Our Ref: 23084

**RE: 15-17 LUPIN AVENUE AND 82 BELMORE STREET, FAIRFIELD EAST (DA 294.1/2023)
RESPONSE TO COUNCIL RFI**

Fairfield City Council (Council) has provided an assessment of the DA submission, requesting further information to continue their consideration of the application. This letter reproduces the traffic and parking related matters with responses provided thereafter.

FIGURE 3.3 MINIMUM SIGHT LINES FOR PEDESTRIAN SAFETY

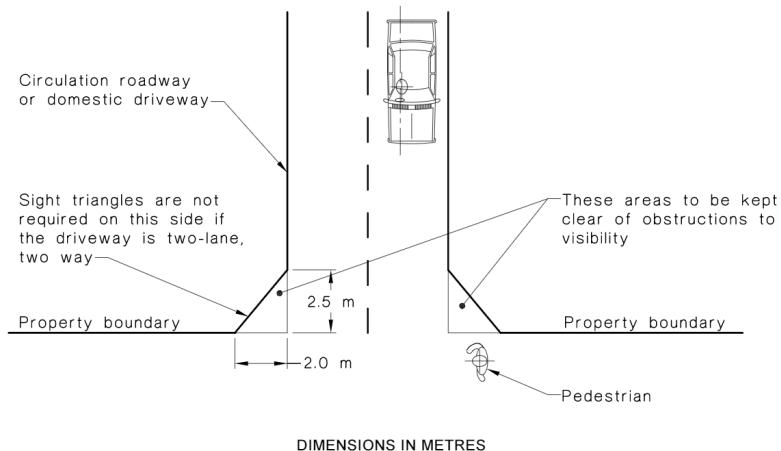
The sight triangle to the left of the driver is to be kept clear of obstructions to visibility as shown in figure 3.3 of AS2890.1:2004. This is required to ensure the motorist can sight to a pedestrian who may be a child or pram being pushed, this area should not include the neighbouring properties land.

AS2890.1 does not specify the minimum height of obstructions for pedestrian visibility. With sight line triangles provided to enable view of passing pedestrians, the existing fence provides this ability when considering that most pedestrians would be taller than 1.0m or walking with someone who is (i.e. children with their guardians). Therefore, the height of the existing fence is considered appropriate from a AS2890.1 sight line requirement compliance perspective.

It is noted that sight lines would improve with the proposed development as vehicles will be able to enter and exit the site in a forward direction, where comparatively, the existing site requires vehicles to reverse out of the site.

Any landscaping proposed between the driveway and property fence line should either not grow higher than the adjoining fence or regularly be trimmed to maintain the height.

Although not considered necessary, a convex mirror could be installed within the planter box immediately north of the proposed driveway to further aide sight lines between departing motorists and pedestrians approaching from the south.

23084CAD004
FIGURE 2

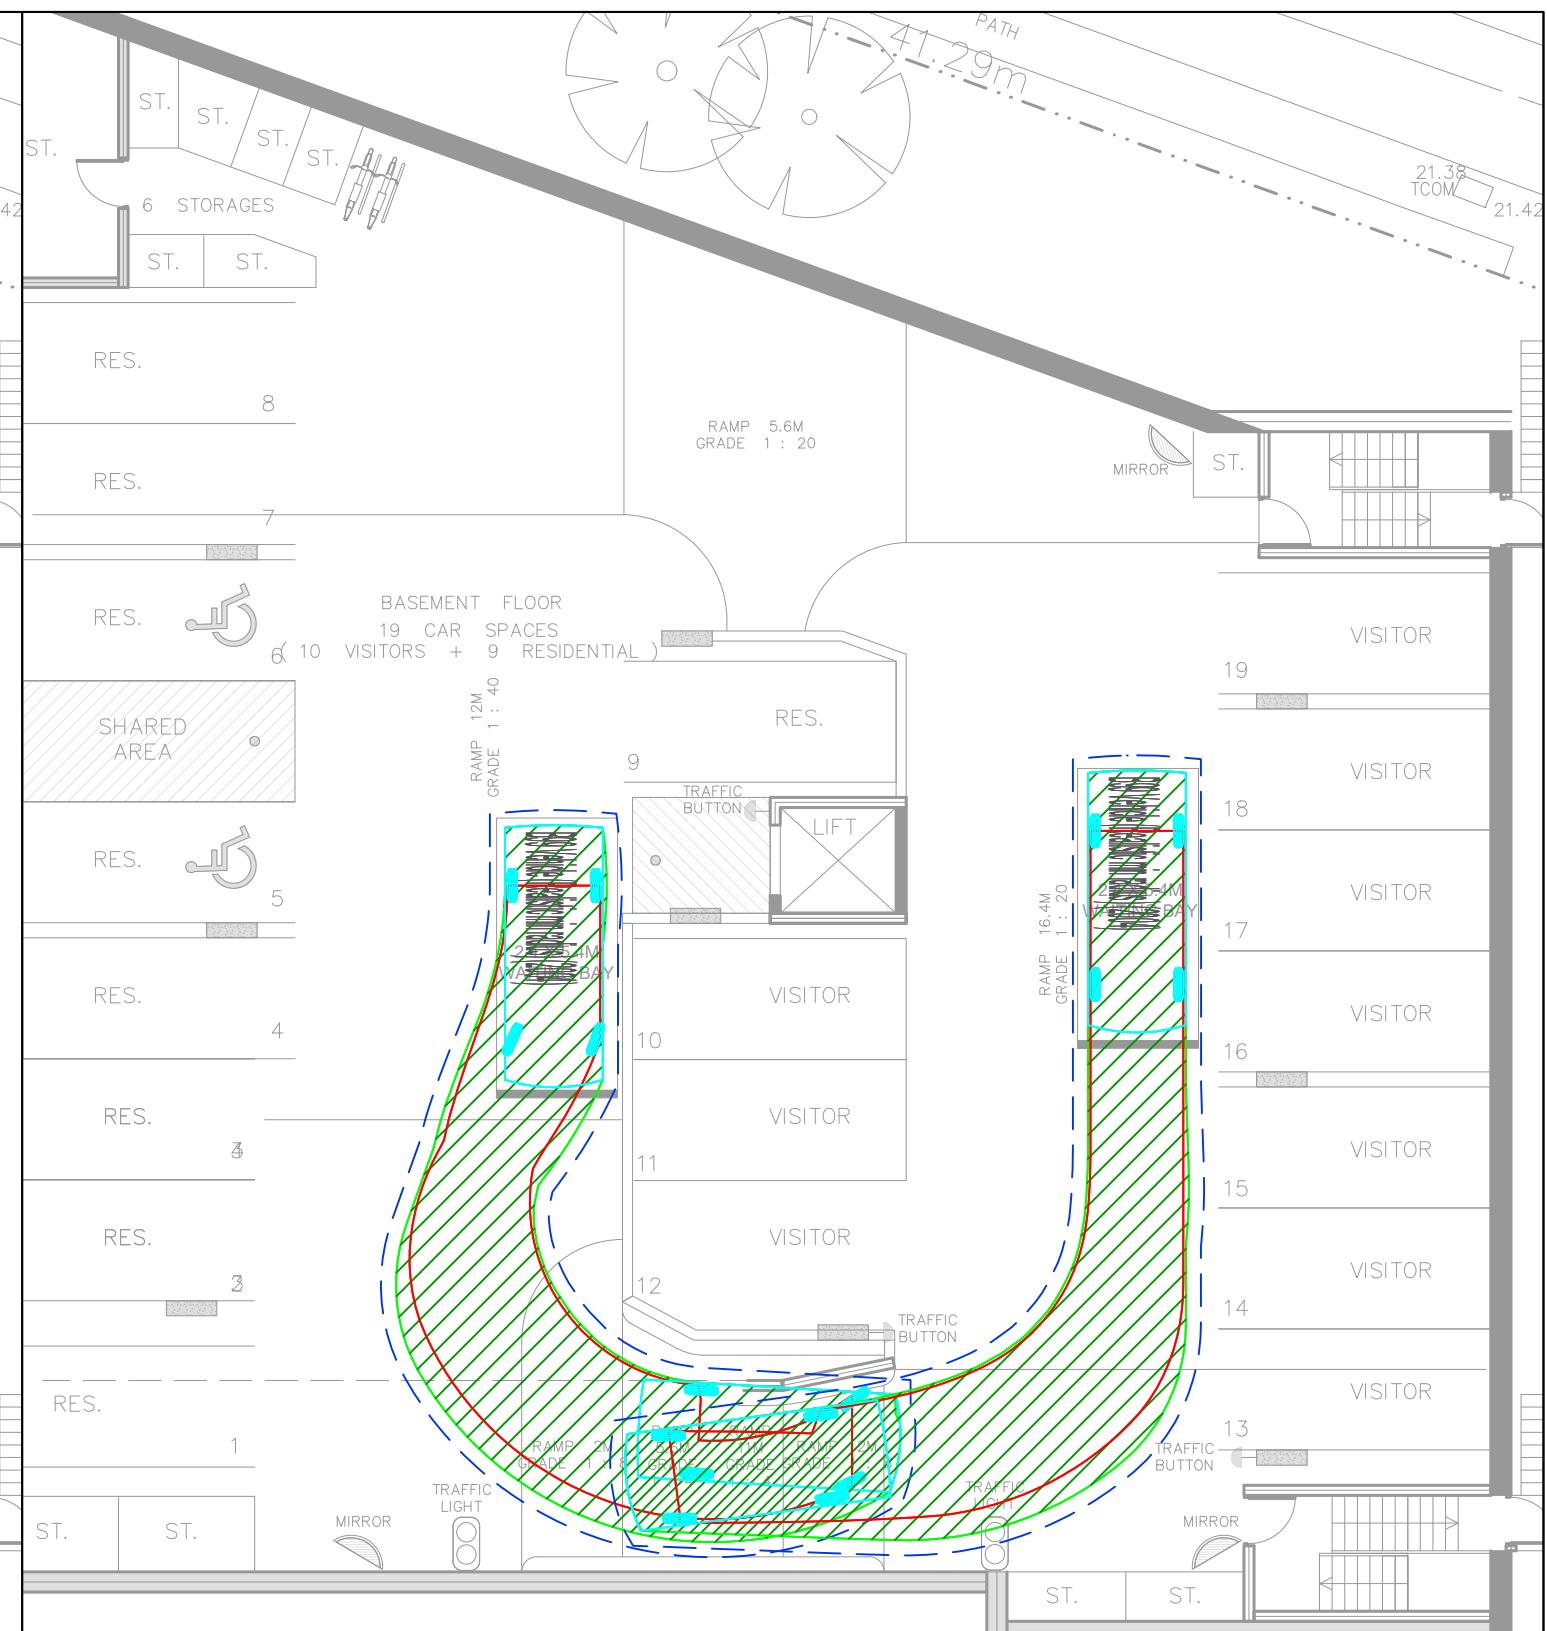
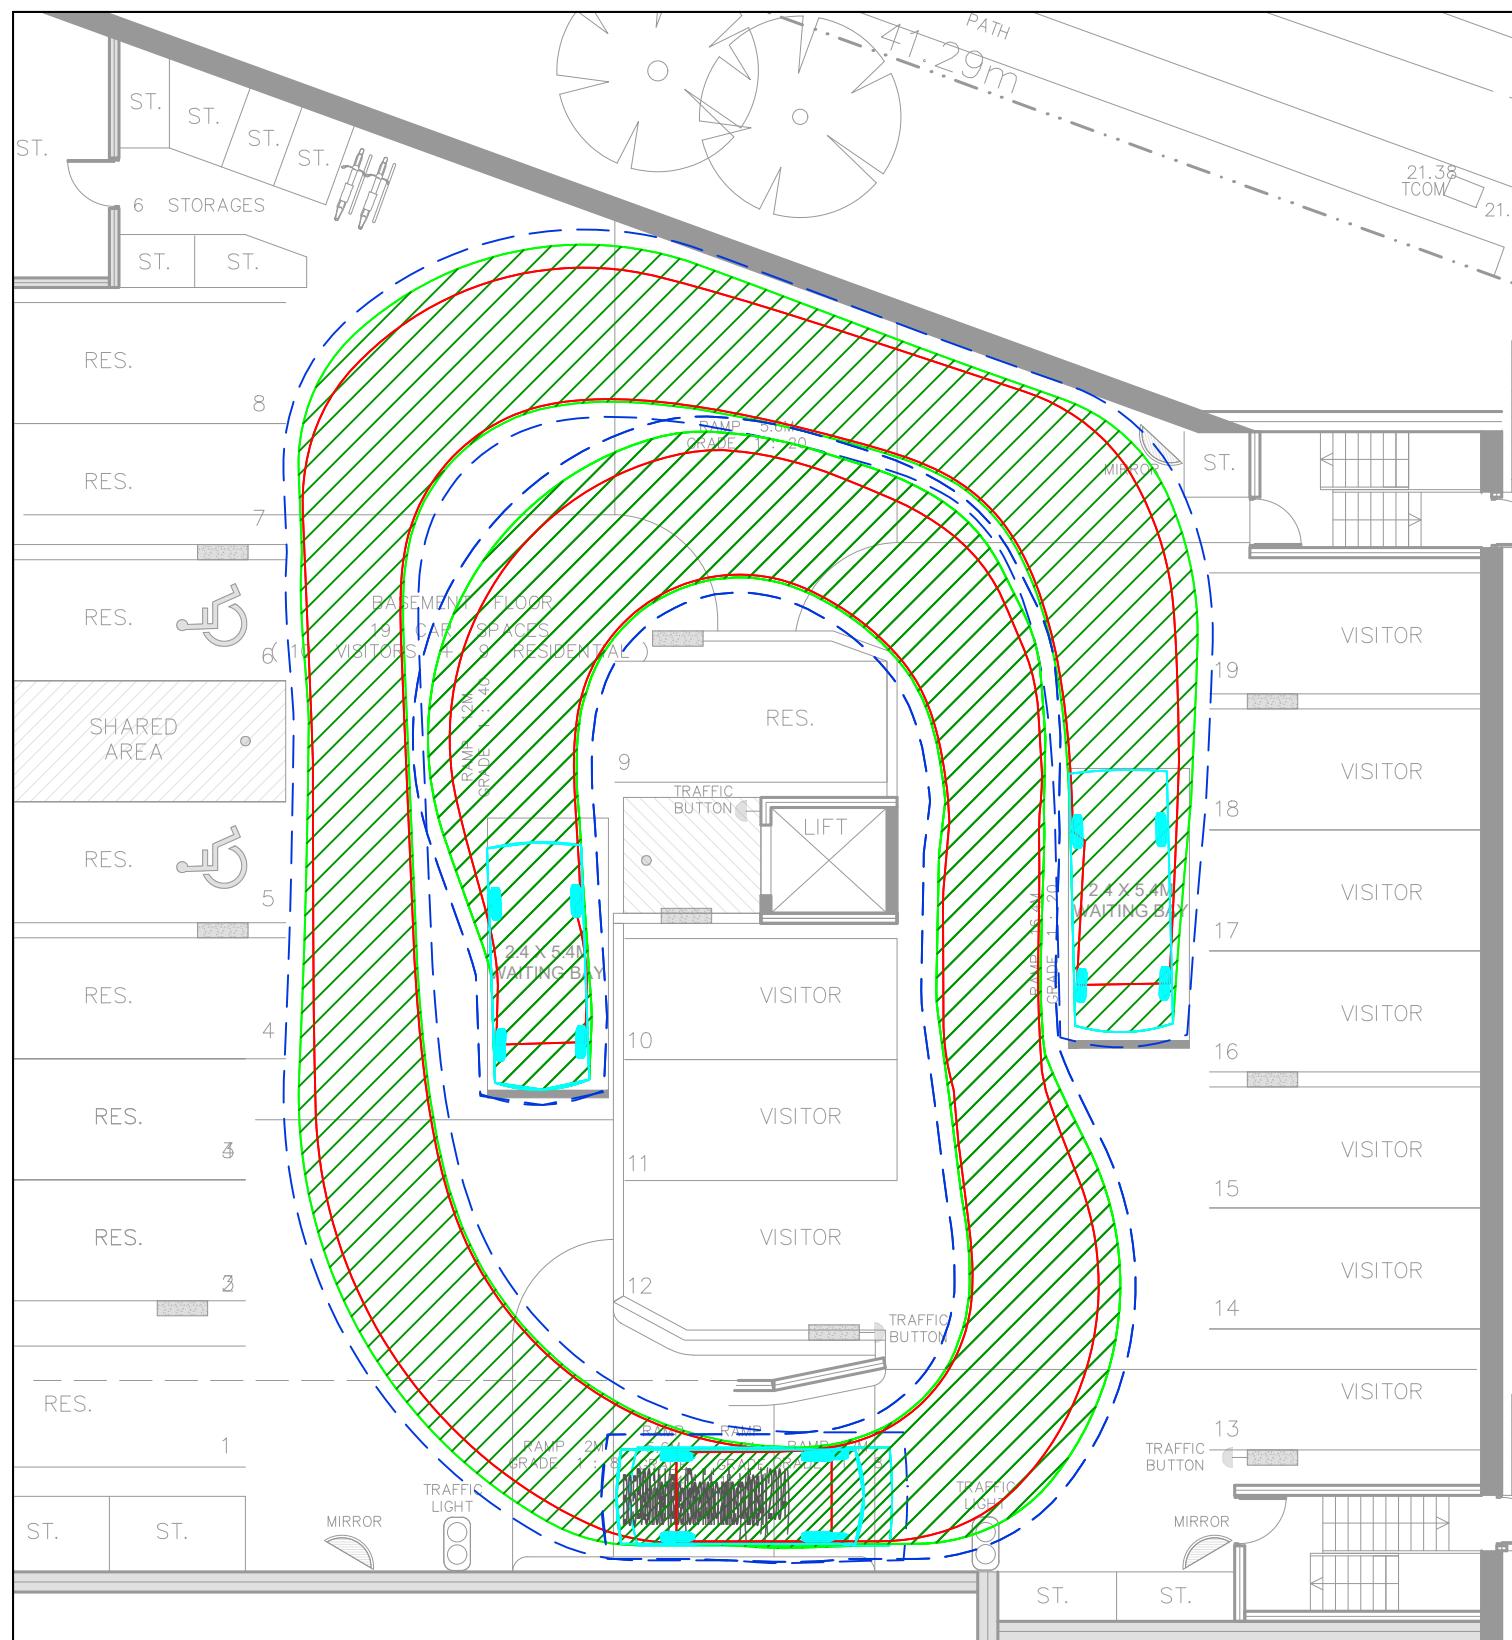
The plans provided in the traffic impact assessment depict that parking space 12 on basement 1 plan and parking spaces 10 on basement 2 plan have stairwells shown within the parking space. The parking spaces and aisle widths should be clear and unobstructed and in accordance to AS2890.1.

It is difficult to determine where the walls and columns are located when reviewing the swept path diagrams. Furthermore, the swept paths for vehicles entering parking spaces have not been shown. It is also not clear how visitors will be able to turn around should visitor parking spaces be in use.

Updated swept path analysis is attached to this letter that clearly illustrate parking spaces and aisles are unobstructed by structure.

Updated swept path analysis is attached to this letter that should more clearly distinguish structure from parking spaces and swept paths.
